Date:	October 18, 2013
To:	Sales Team, Customer Care Representatives & Product Data Group
From:	Jennifer Goff
Re:	Outlook Plus Price Book and Technical Drawing Corrections

AKER PRICE BOOK CORRECTION

Products Affected: Aker Outlook Plus Reduced Skirt Units

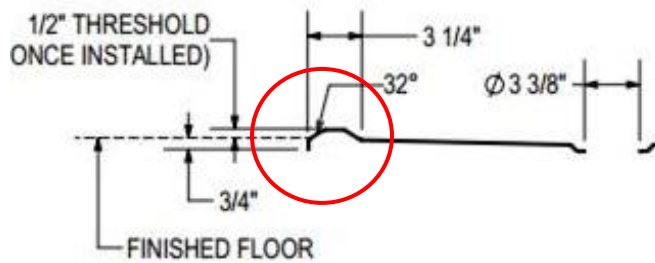
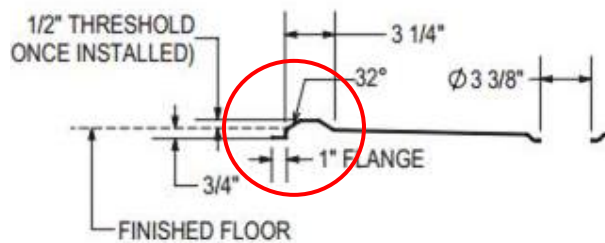
- **Page 12:** The drawing for the 3/4" reduced skirt unit is incorrect. The Aker Outlook Plus reduced skirt units DO have a flange. It is there to provide strength to the unit and prevent warping.
- **Pages 21, 27, 34:** All drawings for "RS" (reduced skirt) units that are provided after each product page are also incorrect.
- **NOTE:** you cannot order the RS unit without a skirt

INCORRECT FLANGE DRAWING

CORRECT FLANGE DRAWING

- **Website:** The technical drawings, builder specs and submittal sheets have all been updated on line.
- **Price Guide:** The electronic price guide in the MAAAX brand center is 100% updated.
